Interactive comment on “WHAT-IF: an open-source decision support tool for water infrastructure investment planning within the Water-Energy-Food-Climate Nexus” by R. Payet-Burin et al.

Received and published: 12 August 2019

Fig. 1.

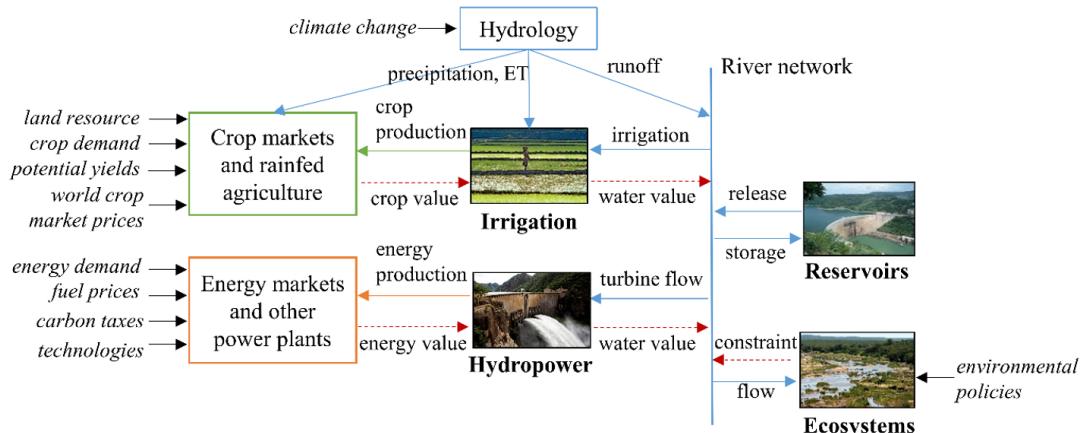
****REVIEWER COMMENT 4**** My main concern is the following; while there is a section discussing different scenarios I am missing some discussions on the sensitivity of each module to one of the other.

ACTION TAKEN To this purpose we added a figure showing the feedback loops among the modules, as suggested by reviewer 2 (page 17, line 9): "The main link in the nexus,

is the water resource for which hydropower, irrigation and ecosystems compete (Figure 2). The energy markets provide a dynamic value to hydropower production, while the crop markets provide a dynamic value of irrigation. The markets are therefore indirectly linked through the water trade-offs between hydropower and irrigation. Exogenous drivers on these markets such as new policies, technological and socio-economic changes, indirectly affect the water trade-offs and therefore all markets."
